UNITED STATES PATENT AND TRADEMARK OFFICE

APPLICATION NO.	FILING DATE	FIRST NAMED INVENTOR	ATTORNEY DOCKET NO.	CONFIRMATION NO.
10/555,646	11/04/2005	Claudiu Vasilescu	1200.740	9696

Office Action Summary

DETAILED ACTION

**FIG. 2**

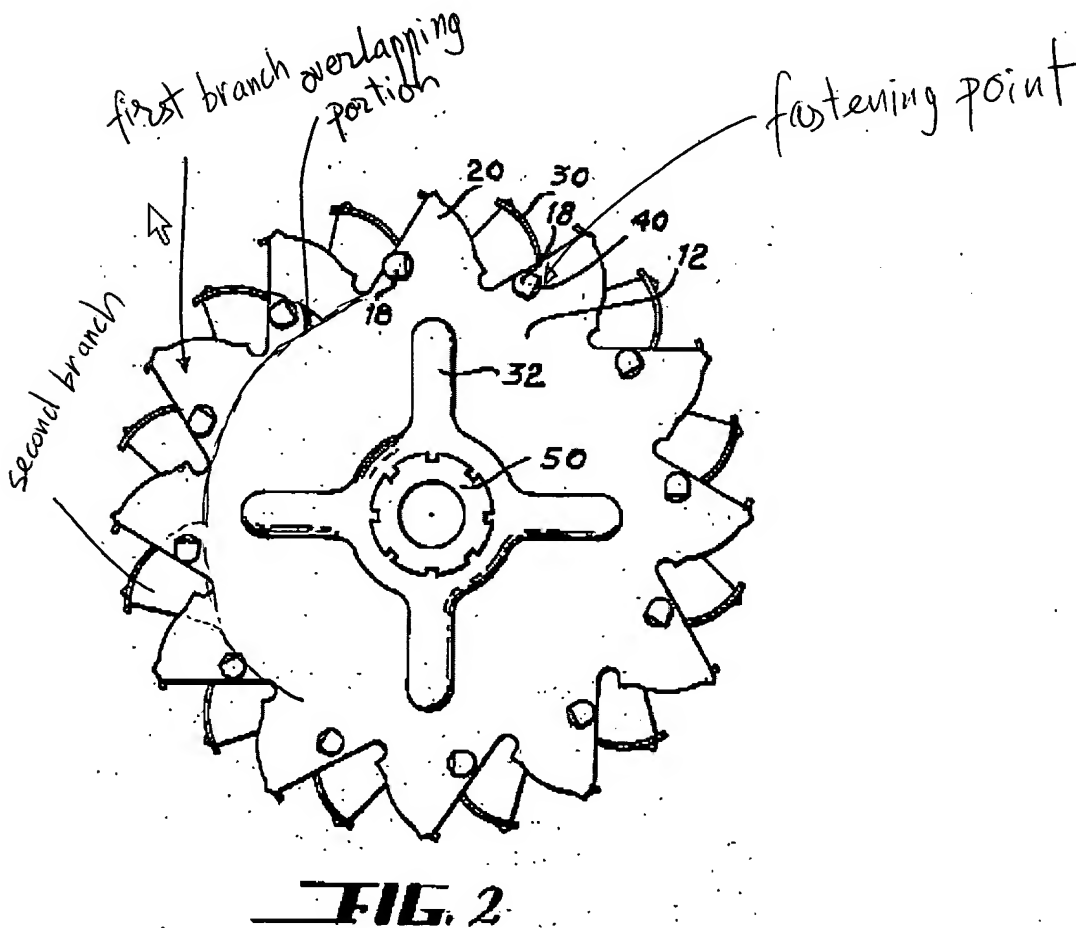
Regarding claim 1, Mayne discloses a ventilating device adapted to be fixed on a transverse end face of an axial end of a rotor of a rotary electrical machine, of the type (preamble, patentable weight not given) comprising: a first fan (10 as described in Col. 2, lines 45-48) comprising a transversely oriented central plate portion, from which first blades (20 in Fig. 2 and 3) extend radially outwards; at least one second fan (10a) comprising a second transversely oriented central plate portion, from which second blades (20) extend radially outwards; and means for fastening the two fans (hole 40 in Fig. 6), wherein each fan (10, 10a) has, extending radially outwards from its outer periphery, first branches and second branches respectively, and wherein at least some

of the said branches carry a blade (30), characterised in that at least one first branch and at least one second branch include a first mutual overlapping portion and a second mutual overlapping portion, to define an overlap zone (please see markups), and in that the said fastening means (40) of the two fans are arranged at least partly in the region of the said overlap zone.

Regarding claim 2, Mayne also discloses a ventilating device wherein the said fastening means of the two fans include at least one fastening point (40) for fastening the said overlapping portions of the two branches together.

Regarding claim 3, Mayne also discloses a ventilating device wherein the said fastening means of the two fans comprise at least two fastening points (40) for fastening the said overlapping portions of the two branches together.

Regarding claim 4, Mayne also discloses a ventilating device wherein the two fastening points (40) are arranged in the vicinity of the opposed ends of the two overlapping portions of the two branches (one in top plate 10, the other one is in bottom plate 10a).

Regarding claim 6, Mayne also discloses a ventilating device wherein one of the fans (10) is so configured that it has fastening points (center hole in Fig. 2) which are adapted to be fixed on the rotor of the rotary electrical machine, and in that the said fastening points are of greater size than the fastening points (40) fastening the two fans (10, 10a) together.

Regarding claim 7, Mayne also discloses a ventilating device wherein balancing means (tabs 18 are locate symmetrically on both sides of the assembly) are located in the region of the fastening point (40 in Fig. 2) by which the said overlapping portions are fastened together.
